**UNITED STATES DEPARTMENT OF COMMERCE
Patent and Trademark Office**

APPLICATION NO.	FILING DATE	FIRST NAMED INVENTOR	ATTORNEY DOCKET NO.
09/135,926	08/18/98	BUSBOOM	G

Office Action Summary

Applicant(s)
BUSBOOM ET AL.

Modified Figure

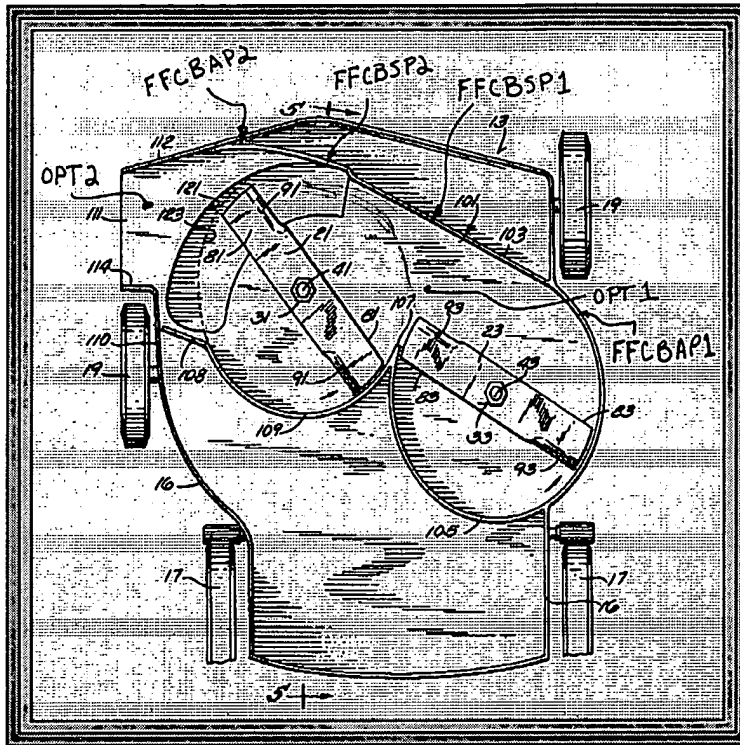
Kidd shows the first flow control baffle comprising a first arcuate baffle portion (FFCBAP1), a first elongated and substantially straight baffle portion (considered the combination of FFCBSP1 & FFCBSP2) and a second arcuate baffle portion (FFCBAP2) as shown in the enclosed modified figure. Kidd further shows the first elongated and substantially straight baffle portion being angularly disposed with respect to the blade tip path of the second cutting blade.

Concerning claim 12, Kidd shows the first and second flow control baffles having spaced-apart arcuate portions (FFCBAP1 & FFCBAP2, 105 & 109) which cooperate to define a semi-enclosed cutting chamber extending partially around the blade tip path of each of said cutting blades as shown in figure 4 and better identified in the inserted figure below.
